Parts List

Change

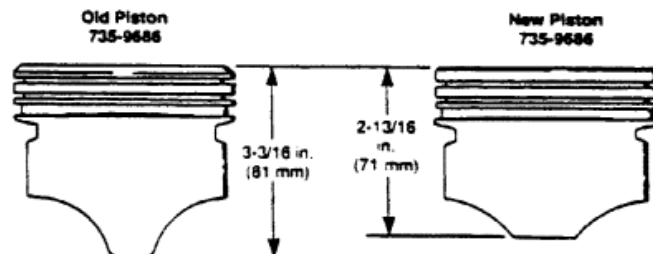
The latest replacement standard pistons (P/N 735-9686) for these engines use a different set of piston rings. The latest piston's oil ring groove is not as deep as the older piston.

The latest replacement piston will be shipped with a set of piston rings.

If piston rings only are required, refer to the drawings before ordering replacement piston ring sets from the chart.
